November 7, 2024

ADDENDUM NO. 01 to the plans and specifications for MACOMB COUNTY – COUNTY WAREHOUSE – F & O AND PURCHASING OFFICE RENOVATION, CLINTON TOWNSHIP, MI, Architect’s Project No. 242053, dated OCTOBER 31, 2024

TYPICAL TV1 POWER AND LOW VOLTAGE DETAIL
NO SCALE

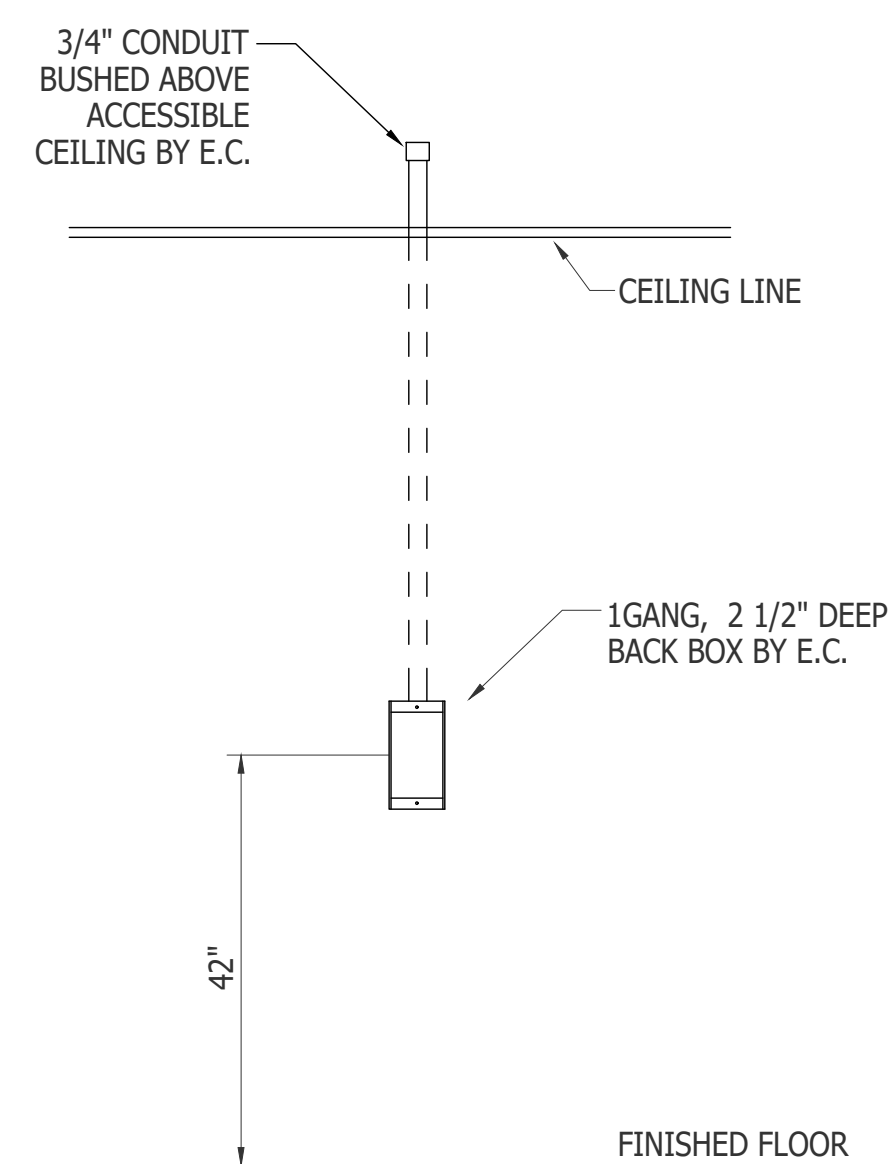
3. Added TV Detail.
 4. Added TV1 Detail.
 5. Added Card Reader Detail.
 6. Added TELE/AV/AV Outlet Detail.
- ITEM NO. E10:** Refer to sheet E6.00 Electrical Panel Schedules (Re-issued);

PARTIAL ONE- LINE DIAGRAMS
NO SCALE

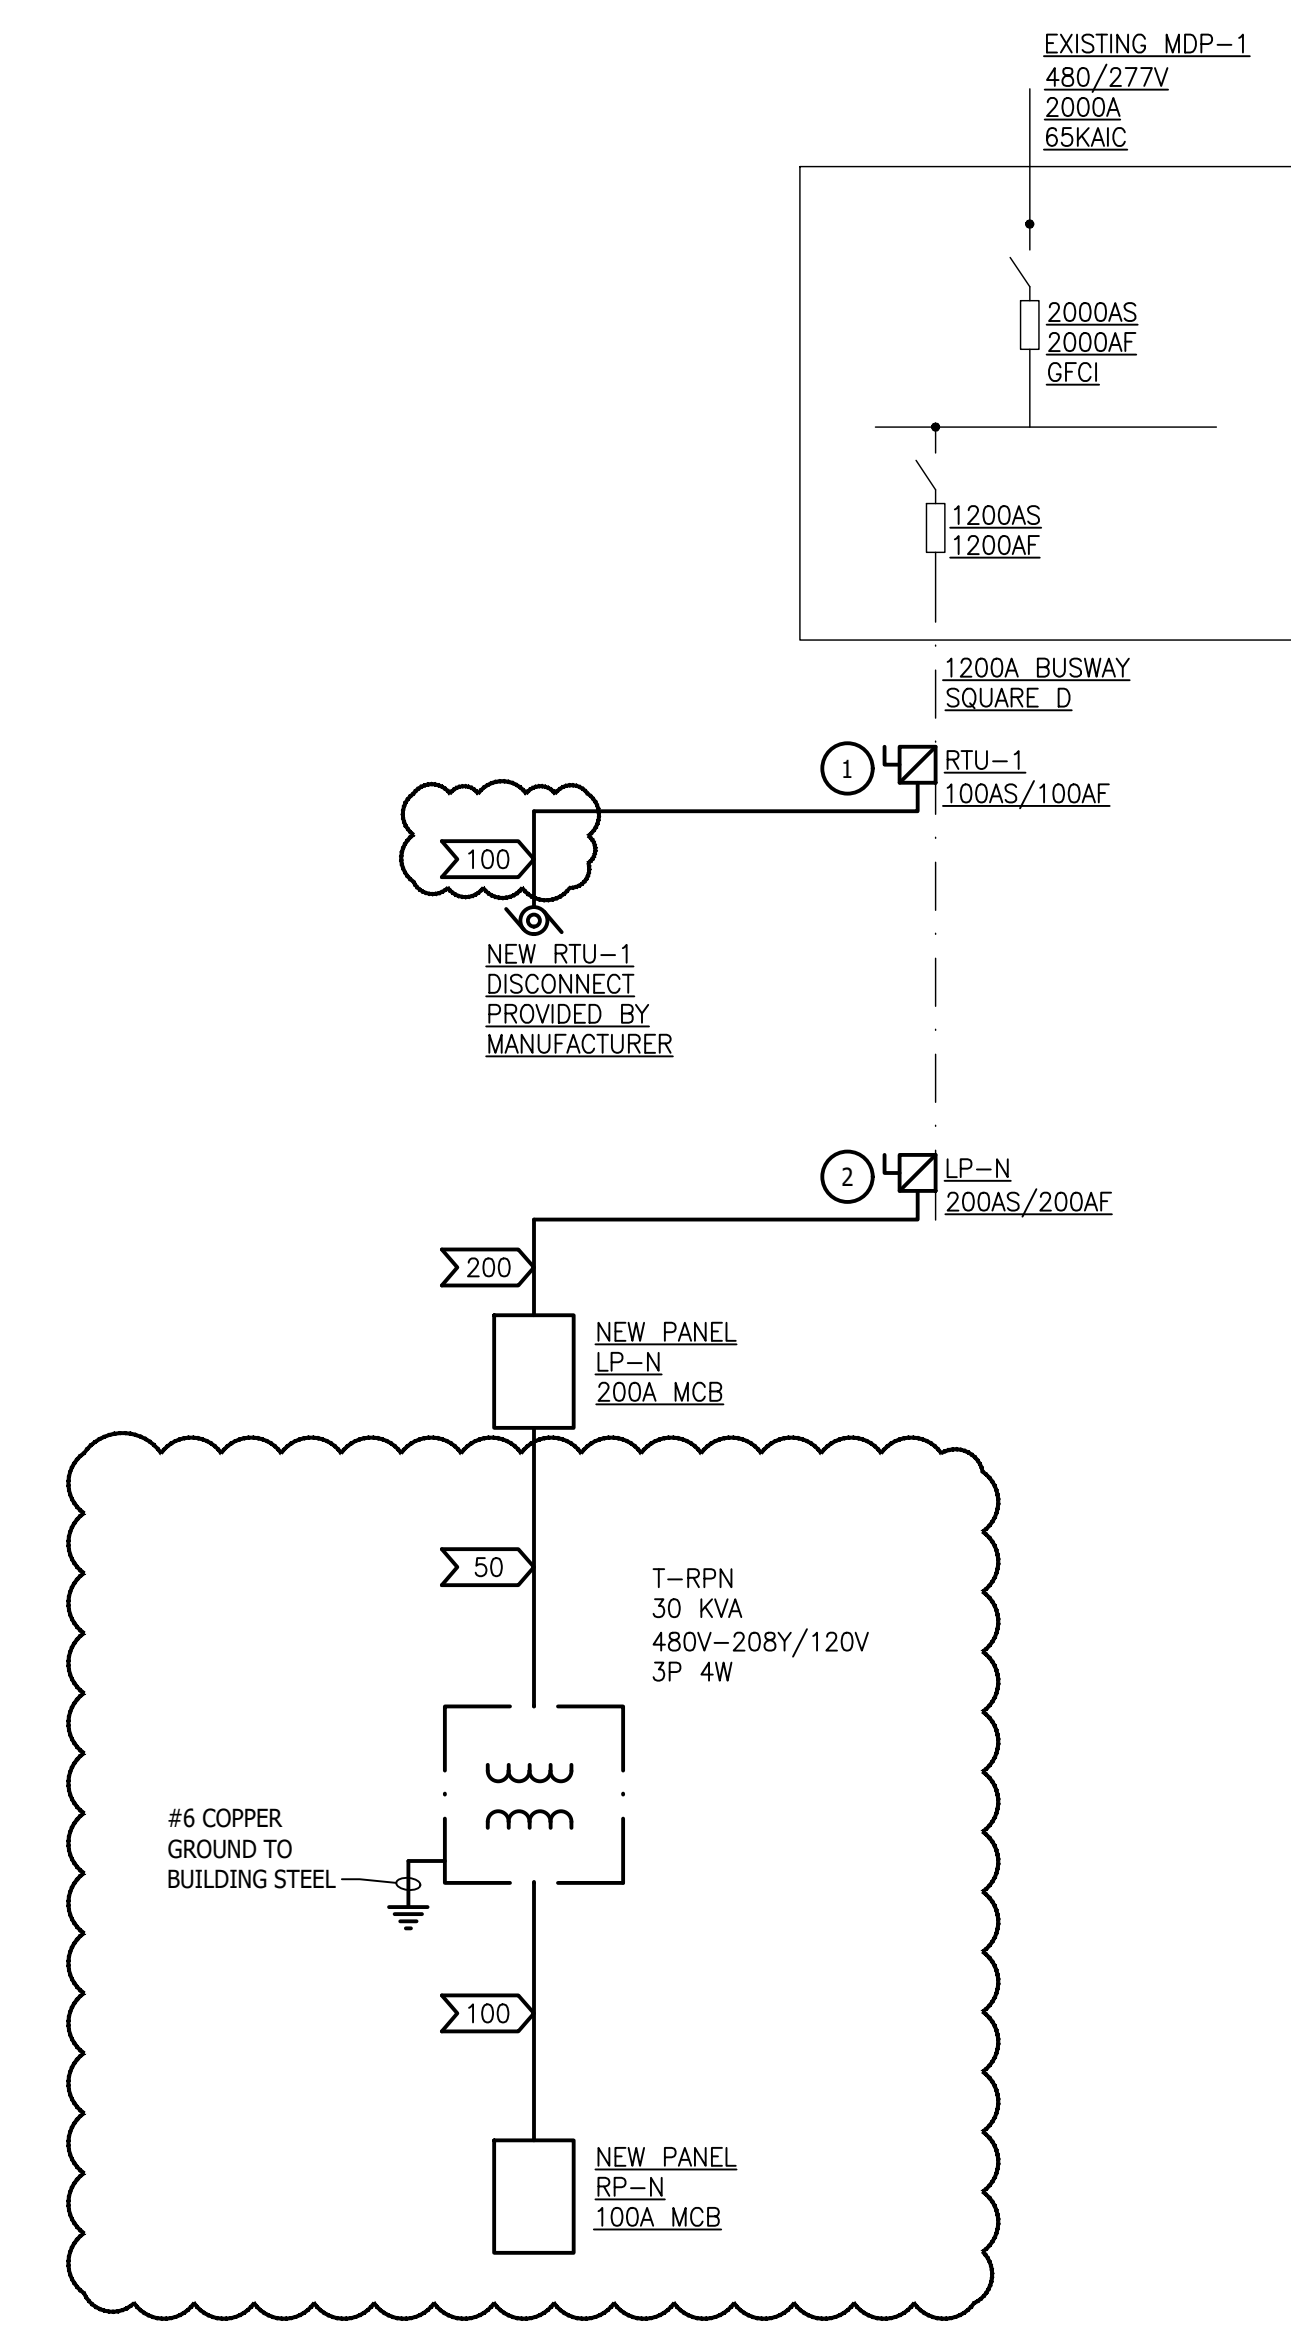
- ITEM NO. E11:** Refer to sheet E7.00 One-Line Riser Diagrams (Re-issued);
1. Adjusted Project number on plans as indicated.
 2. Added RTU-1 feeder tag.
 3. Added transformer T-RPN.
 4. Added panel RP-N.
